## **COVENANT ANNEX SUBDIVISION**

Engineering Comments: FINAL PLAT COMMENTS (should be addressed prior to submitting the FINAL PLAT for review and/or signature by the City Engineer):

# DETAIL SITE PLAN

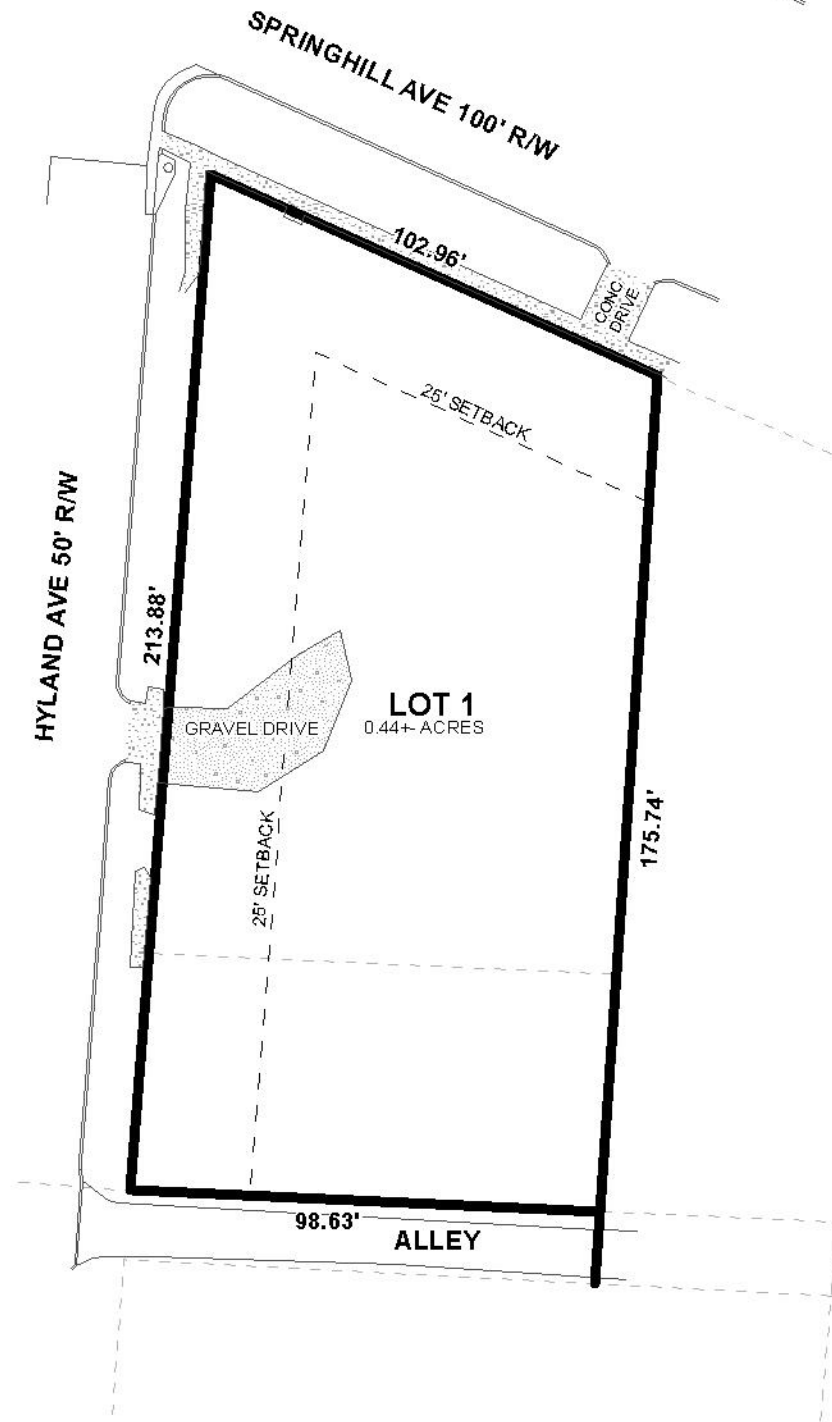
As illustrated on the preliminary plat the proposed lot has frontage along Hyland Avenue and Springhill Avenue. Both Hyland Avenue, a minor street with curb and gutter, and Springhill Avenue, a major street included in the major street plan, are illustrated on the preliminary plat showing compliant rights-of-way. However, the applicant should coordinate with the City Engineer to determine if a corner radius dedication is required, per Section V.D.6. of the Subdivision Regulations. Additionally, a compliant 25-foot minimum building setback is illustrated along both frontages and should be retained on the Final Plat.

The proposed lot meets the minimum size requirements of the Subdivision Regulations and as such, the lot size label in both square feet and acres should be retained on the Final Plat, adjusted for dedication if necessary, or a table should be furnished on the Final Plat providing the same information.

No easements are indicated on the preliminary plat. If any easements are recorded on the site they should be indicated and labeled on the Final Plat, and a note should be placed on the Final Plat stating that no structure may be placed or constructed within any easement without permission of the easement holder.

- 1) Coordination with the City Engineer to determine if a corner radius dedication is required, per Section V.D.6. of the Subdivision Regulations;
- 2) Retention of the 25-foot minimum building setbacks along both Hyland Avenue and Springhill Avenue on the Final Plat, adjusted for dedication if necessary;

- 3) Retention of the lot sizes in both square feet and acres, adjusted for dedication if necessary, or the furnishing of a table on the Final Plat providing the same information;

- 4) Placement of a note on the Final Plat stating that no structure may be constructed or placed within any easement without permission of the easement holder, if applicable;
